Version with markings to show changes made

--APPARATUS AND METHOD FOR ALIGNING VARIABLE-WIDTH INSTRUCTIONS WITH A PREFETCH BUFFER--.

FIG. 3

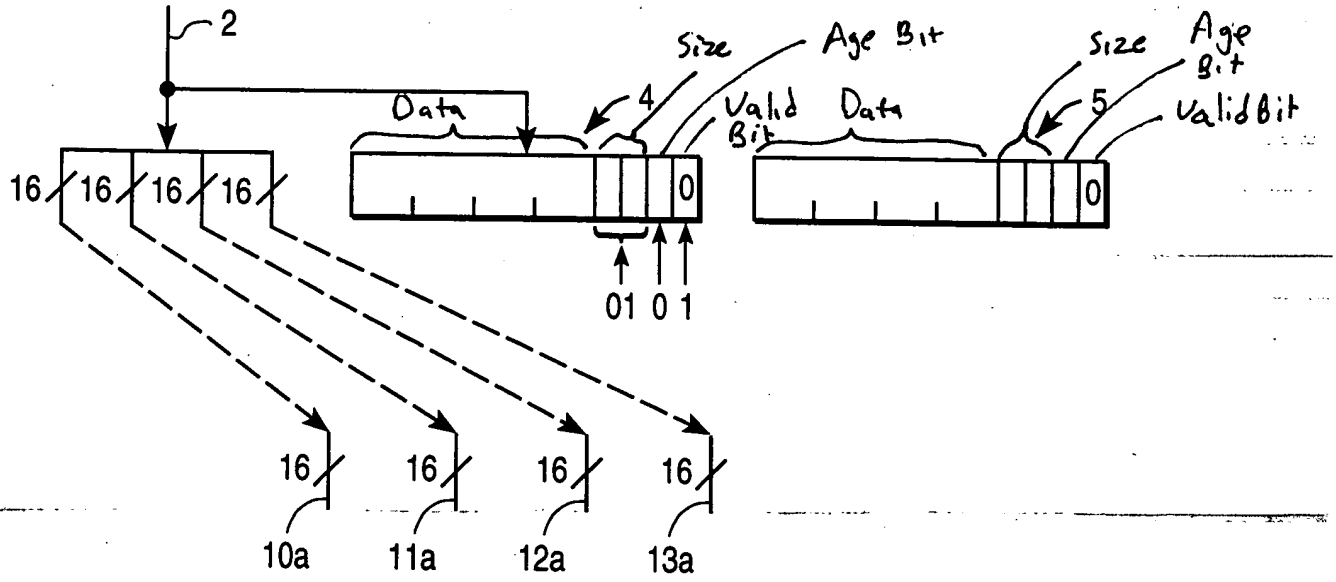
Please accept the amended Figures 3-5, in which changes to the drawing sheets are shown in red.

Figures 3-5 have been amended to add the labels as requested by the Examiner.
